## City of El Paso - City Plan Commission Staff Report

Case No: PZST15-00039

**Application Type:** Special Permit and Detailed Site Development Plan

**Location:** 6010 Tampa Avenue

# ATTACHMENT 3: DETAILED SITE DEVELOPMENT PLAN

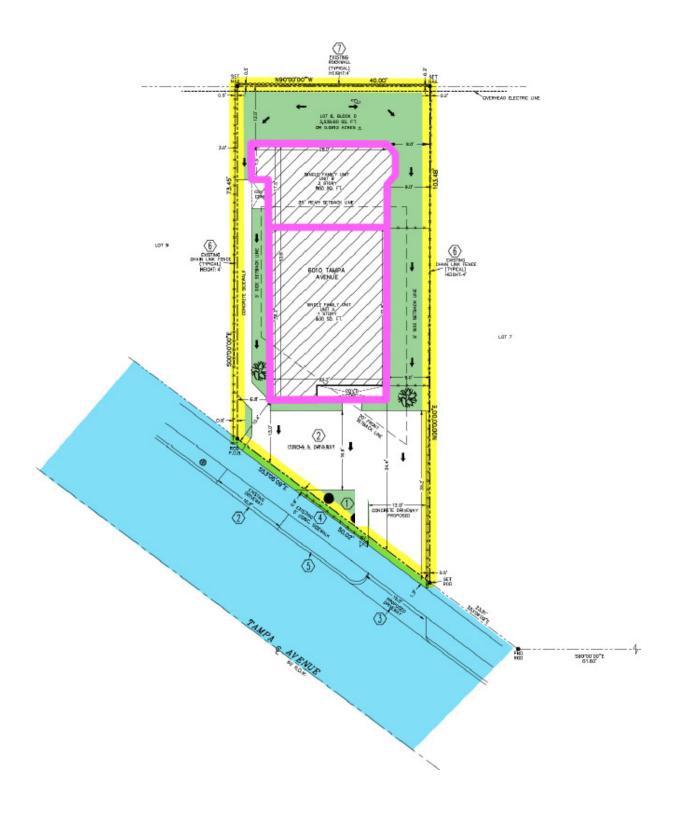
The applicant is requesting a special permit for infill development and detailed site development plan review for an infill development to reduce the side yard and cumulative front and rear yard setbacks for a duplex. The detailed site development plan shows a new 1,725 sq. ft. duplex. The applicant is requesting the following reductions: from the required 5 ft. side yard setback to 3 ft. and from the required 45 ft. cumulative front and rear yard setback to 22 ft. (see the table on page 3). The Detailed Site Development Plan complies with all other density and dimensional standards per the approved legal non-conforming registration. The proposed development requires four parking spaces and the applicant is providing four parking spaces. Access to the subject property is proposed from Tampa Avenue.

The applicant is requesting the following reductions: from the required 5 ft. side yard setback to 3 ft. and from the required 45 ft. cumulative front and rear yard setback to 22 ft.

Planning Staff has reviewed the detailed site development plan, and it meets all requirements of Sections 20.04.320, Special Permit, and 20.04.150 Detailed Site Development Plan.
